Cefndon Farm,
Neath Road, Tonna,
Neath Port Talbot

Road Safety Audit - Stage 1

Barratt Homes /
David Wilson Homes

December
2016

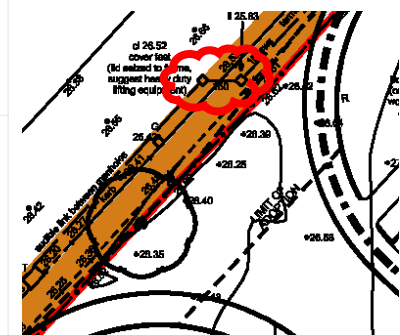
2.1.1 **Problem** Surface water ponding on existing footway

Location Western side of carriageway adjacent to proposed development boundary

The Audit Team noted from the site visit areas of surface water ponding on the footway along the eastern edge of the B4434 Neath Road. The Audit Team is concerned that during cold weather the water may freeze and present a slip/trip hazard to pedestrians.

The Audit Team recommends that the appropriate cross-falls across the footway are provided to prevent excess surface water.

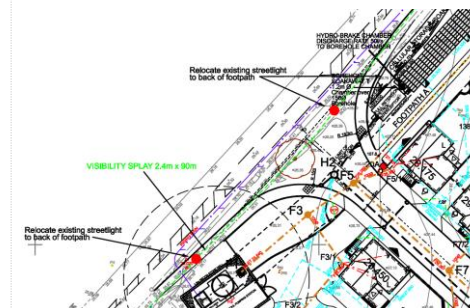
2.2.4	Problem Large vehicles may overrun pedestrian facilities	
	Location Proposed site access junction	
The Audit Team note from the Engineering Layout (1605/201K) that the tactile paving, located at the proposed site access, is situated along the radius of the kerb-line. In the absence of any swept-path analysis, the Audit Team is concerned that large

vehicles turning into the proposed access may overrun the tactile paving, potentially leading to conflict with pedestrians, resulting in vehicles striking pedestrians.

The Audit Team recommends that the tactile paving is set back along the proposed access approximately one metre beyond the radius of the kerb, as per guidance set out in the Department of the Environment, Transport and the Regions' 'Guidance on the use of Tactile Paving Surfaces' and the Department for Transport's Local Transport Note 2/95 'The Design of Pedestrian Crossings'.

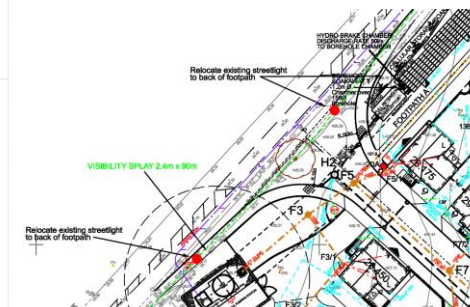
2.2.5 **Problem** Tactile paving situated on kerb-line radius

Location Proposed site access junction

The Audit Team note from the Engineering Layout (1605/201K) that the tactile paving, located at the proposed site access, is situated along the kerb-line radius of the proposed access. The audit team is concerned that this increases the time it will take pedestrians to cross the side road, thereby increasing the likelihood of pedestrians being hit by a vehicle.

The Audit Team recommends that the tactile paving is set back into the minor road approximately one metre beyond the radius of the kerb, as per guidance set out in the Department of the Environment, Transport and Regions' 'Guidance on the use of Tactile Paving Surfaces' and the Department for Transport's Local Transport Note 2/95 'The Design of Pedestrian Crossings'.
